PROJECT: Summerlin West V25 - Scurry Bend Drive Improvements

CITY OF LAS VEGAS INTER-OFFICE MEMORANDUM		DATE: June 3, 2021
TO: Land Development Services Department of Building & Safety		FROM: Albert Sung, P.E. Flood Control Project Engineer Department of Public Works
SUBJECT:	Drainage Study for:	COPIES TO:
Summerlin West V25 - Scurry Bend Drive Improvements (from Sunset Run Dr. to Lake Mead Blvd.)		Atkins
Cross Streets:	Scurry Bend Drive. & Lake Mead Boulevard	Howard Hughes Company, LLC
File Number:	F:\Depot\DSMemos\DS5427C.doc	Bart Anderson, P.E., DevCo
Parcel Number:	137-15-801-002 & more	
Zoning Action:	N/A	
FEMA Flood Zone	YES NO X	
Proposed Storm Drain	YES X NO

Addendum #2

**RE: ADDENDUM #2 TECHNICAL DRAINAGE STUDY FOR SUMMERLIN WEST VILLAGE 25
SCURRY BEND DRIVE – SUNSET RUN DRIVE TO LAKE MEAD BOULEVARD**

STORM DRAIN LATERAL 3
"SBD" STA. 25+99.76 SEE SHEET 17

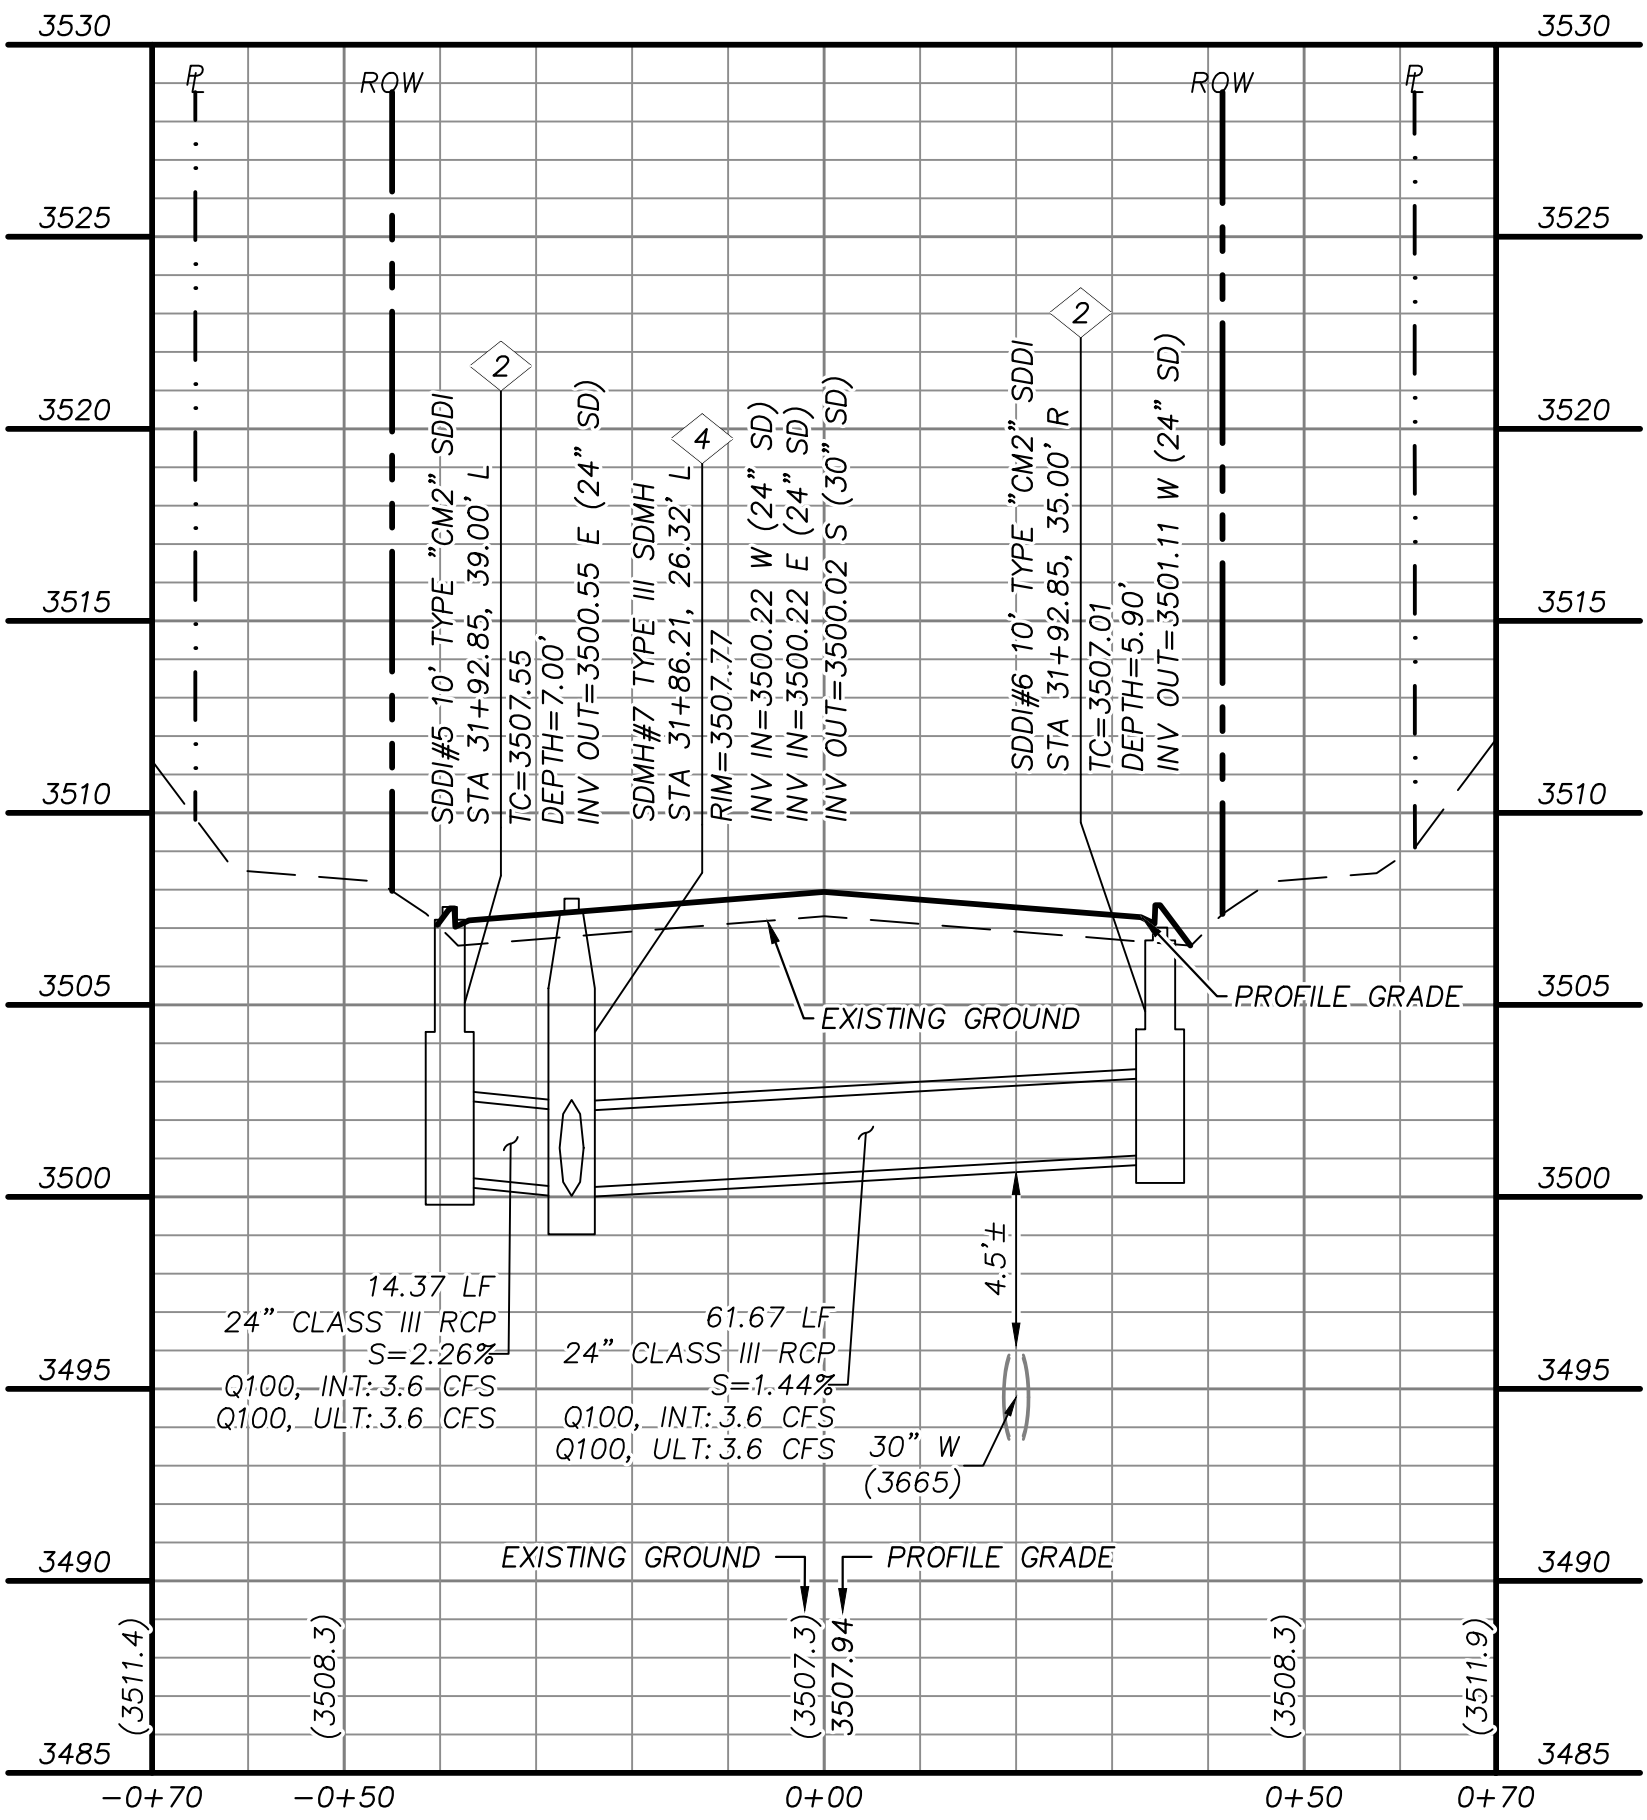
Comment #6: Previous Comment #18: *Indicate the length and depth of the inlets on all pertinent plans. Any inlets deeper than 10' require City Building & Safety Department review and approval of the structural design and calculations.*

It is still not clear what's the depth of SDDI #4.

Comment response: The drop inlet labels on the Sheet 24: Storm Drain Lateral Profiles have been updated with that specify the inlet length and depth.
